Access Compliance Report Public Rights-of-Way (Curb Ramps)

Main Street: PROSPECT_AVE Cross Street: AMAGANSET_WAY Location: SW

ADA ID: RPRK220121133411 Ramp Type: Type 4 - Parallel Initial Pass/Fail: Fail Overall Compliance: No Severity Score: 2

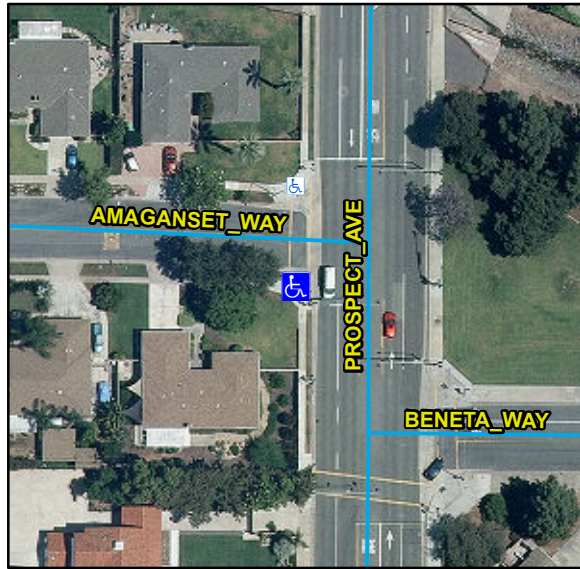
Compliance	Description	Data	Compliance	Description	Data
N/A	Ramp Length LT (in)	84	N/A	Ramp Length RT (in)	85
Yes	Ramp Width LT (in)	112	Yes	Ramp Width RT (in)	112
Yes	Ramp Run Slope LT (%)	2.5	Yes	Ramp Run Slope RT (%)	4.7
No	Ramp Cross Slope LT (%)	3.6	Yes	Ramp Cross Slope RT (%)	0.1
N/A	Landing Present	N/A	N/A	DWS Provided	N/A
N/A	Landing Length (in)	N/A	N/A	DWS Contrast	N/A
N/A	Landing Width (in)	N/A	N/A	DWS Length (in)	N/A
N/A	Landing Run Slope (%)	N/A	N/A	DWS Full Width	N/A
N/A	Landing Cross Slope (%)	N/A		DWS Offset Type	N/A
N/A	Landing Movement Obstructed?	N/A	N/A	DWS Offset Left (in)	N/A
	Landing Movement Type	N/A	N/A	DWS Offset Right (in)	N/A
N/A	Landing Shared	N/A			
N/A	Clear Space	Yes			
N/A	Clear Space To Crosswalk (in)	N/A			
N/A	Marked Crosswalk 1	No	N/A	Marked Crosswalk 2	Yes
	Crossing 1 Direction	E		Crossing 2 Direction	N
	Marked Crosswalk 1 Width (in)	N/A		Marked Crosswalk 2 Width (in)	144

Remove & Replace Curb Ramp With Two New Directional Ramps or Equivalent.
